NOTE:
SEE DWG NO. C3-222, 01-03-01 FOR GENERAL NOTES, ABBREVIATIONS AND SYMBOL LIST.

UNIT: 5029
CGPL:

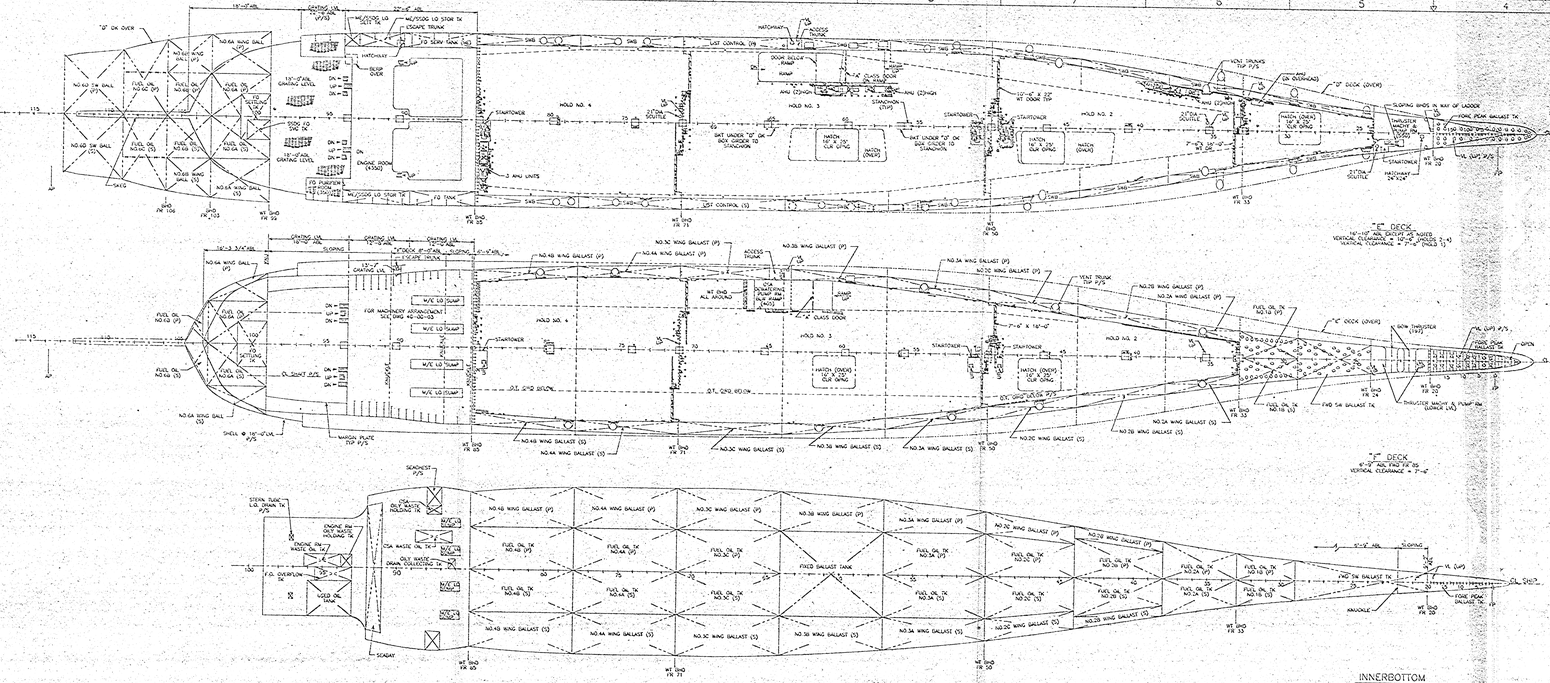
NO	DATE	BY	DESCRIPTION
A	6/1/94		1. CHANGED LOCATION OF LT. DOORS ON STRAPS TO SUIT STRUCTURAL DEVELOPMENT.
B	7/1/94		2. ADDED SEA CHEST/VENTS ON SHEET 33 TO FWD SIDE OF FR. 50 PER DWG. NO. 802-6976057
	8/1/94		3. CONSOLIDATED REVISED DRAWING TO UPGRADE WITH C & R DRAWINGS.
	9/1/94		4. ADDED LOCATION AND REVISED CALLOUT OF DOOR, HATCH AND VENT TRUNK AT "E" DECK RAMPS TO REACH "FINE" DOOR TO COMPUTER.
	10/1/94		5. UPDATED STRAP DECK OUTLINES TO SUIT STRUCTURAL DEV.
	11/1/94		6. ADDED MOON PROTECTION TO VENTS P/S AT FR. 70 TO SUIT DEVELOPMENT.
C	1/1/95		1. UPDATED VENTILATION ARRGT. TO SUIT STRUCTURAL DEV.
	2/1/95		2. ADDED ACCESS TO ALL STARTOWERS DELETED TO SUIT DEVELOPMENT.
	3/1/95		3. ADDED RELOCATED TRUNK CASING TO SUIT DEVELOPMENT.
	4/1/95		4. RELOCATED LADDER ON UNITS ON STARTOWERS AT FR. 33 TO SUIT DEVELOPMENT.
	5/1/95		5. ADDED CASING ON "E" DECK AT FR. 33 TO SUIT DEVELOPMENT.
	6/1/95		6. REVISED CONFIGURATION OF "E" DECK RAMPS TO SUIT DEVELOPMENT.

7/1/95		7. DELETED SPLICED CASING BEND, NO. CALLOUT (DRWN ON SHEET 33 AT FR. 33 PORT & STBD) AND ADDED 2 SEPARATE PIECES TO SUIT MAKING TO 3" & 2" ANGLE ADDED LADDERS TO SEAT TRUNKS TO SUIT.
	8/1/95		8. GENERALLY UPDATED DRAWING TO SUIT DEVELOPMENT.

ITEM #7 TO SUIT ODW 2005-250-6-020-2, DATED AUG. 22, 1995.
			SYSTEM 5/7/2001 APPROVED 5/31/2001
D	9/1/96		1. RELOCATED LONG FOR ADDT. OF SHAFT FROM "E" TO "F" DECK AT AFTERMOST FR. 33. 34 CASINGS.
	10/1/96		2. ADDED GUARD RAIL FOR STORM LIMITS RAMPS ON "E" DECK FR. 31 PORT SIDE. FOR SHAFTING DEV.
	11/1/96		3. EXTENDED DWG. APPLICABILITY TO INCLUDE T-AKR 320
			APPROVED 12/31/96

NO	DATE	BY	DESCRIPTION
1	1/1/94		1. ADDED SHEER AT FR. 69 AT 12'-0" ABOVE "E" DECK TO SUIT STRUCTURAL DEVELOPMENT.
2	2/1/94		2. ADDED CRANE TRUNK.
3	3/1/94		3. ADDED VENT TRUNK AT FR. 33.
4	4/1/94		4. ADDED VENT TRUNK AT FR. 33.
5	5/1/94		5. ADDED VENTS & MOON PROTECTION AT FR. 50.
6	6/1/94		6. ADDED STARTOWER AT FR. 50.
7	7/1/94		7. ADDED CASING TO VENT TRUNKS & VENT TRUNK AT FR. 33.
8	8/1/94		8. ADDED STARTOWER AT FR. 24.
9	9/1/94		9. ADDED VENT TRUNK AT FR. 50 FROM "E" & "F" DECKS TO ENGINE ROOM.
10	10/1/94		10. RELOCATED ESCAPE TRUNK FROM FR 50-70 FR 31
11	11/1/94		11. ADDED COLUMN @ FR. 67 STBD FROM "E" & "F" DECKS.
12	12/1/94		12. ADDED TRUNK CONNECTION FROM FWD TO AFT FR 50 AT "E" DECK.
13	1/1/95		13. RELOCATED ESCAPE TRUNK FROM FR 50-70 FR 31
14	2/1/95		14. DELETED COLUMN @ FR. 67 STBD FROM "E" & "F" DECKS.
15	3/1/95		15. ADDED CONNECTION FROM FWD TO AFT FR 50 AT "E" DECK.
16	4/1/95		16. ADDED GENERAL NOTE, ABBREVIATION AND SYMBOL LIST HOUSE.

17	5/1/95		17. ADDED SCALE BAR.
18	6/1/95		18. ADDED VENT TRUNK ON STBD SIDE TO AT FR. 24
19	7/1/95		19. ADDED VENT TRUNK FOR ENGINE ROOM.
20	8/1/95		20. ADDED OPENINGS IN "E" DK ABOVE PUMP ROOM & RUM THRUSTER EQUIP. ROOM.
21	9/1/95		21. ADDED VERTICAL LADDER IN CARGO HOLD.
22	10/1/95		22. ADDED LONG TWD OF SHELL STWD FWD 100, @ 10'6" ABV "E" DK AT AFTERMOST FR 33. 34 CASINGS.
23	11/1/95		23. UPDATED MACHINERY SPACES TO SUIT DEVELOPMENT.
24	12/1/95		24. DELETED SHAFT TUNNEL CASING FOR BETWEEN FR'S 33 & 34 TO SUIT DEVELOPMENT.
25	1/1/96		25. ADDED TANK DIVISIONS TO SPACE FWD OF FR. 33 TO SUIT DEVELOPMENT.
26	2/1/96		26. UPDATED STRUCTURE AT FR. 33 TO SUIT DEVELOPMENT.
27	3/1/96		27. ADDED ADDITIONAL 10 LNG ADDED OVER AND DELETED LONG FROM FR 31 PORT FROM SHEER AND PUMP RM.
28	4/1/96		28. MOVED AFT END OF PUMP RM AT FR 33 PORT ON "E" DECK TO FR 34 TO SUIT DEVELOPMENT.
29	5/1/96		29. DELETED TRUNK CASING AT FR. 70 TO SUIT DEVELOPMENT.

30	6/1/96		30. DELETED TRUNK AT FR. 70 TO SUIT DEVELOPMENT.
31	7/1/96		31. DELETED TRUNK AT AFT SIDE FR. 33 AND RELOCATED TRUNK AT AFT SIDE FR. 34 TO SUIT DEVELOPMENT.
32	8/1/96		32. INCREASED GM MACHINERY UNITS (MAIN) TO SUIT DEV.
33	9/1/96		33. DELETED LONG BHD. PORT FR 33 & 34 TO SUIT DEVELOPMENT.
			SYSTEM 4/21/94 APPROVED 5/31/94
A	1/1/95		1. "E" DECK REVISED TANK OF PUMP RM UNDER "E" DECK TO REDUCE TANK DIMENSIONS FOR PROPER SOUNDING.
B	2/1/95		2. RELOCATED SET-ON/OFF BELOW "F" DECK TO ALIGN WITH LONG S'ND ABOVE "F" DECK AND RELOCATED LONG BHDS. IN TANK BELOW TO SUIT FULL DEV.
C	3/1/95		3. WIDENED ESCAPE TRUNK AT FR 50 PORT AT "E" & "F" DECKS AND RELOCATED AFT END OF "F" DECK TO SUIT DEVELOPMENT.
D	4/1/95		4. UPDATED STARTOWER AT FR 24, "E" DECK TO SUIT OUTFITTING DEVELOPMENT.
E	5/1/95		5. REVISED SIZE OF CLEAR OPNG FOR RAMP DOOR FROM 2'-10" & 18" TO 11'-8 1/2" TO CONFORM.
			REVISIONS CONTINUED NEXT COLUMN
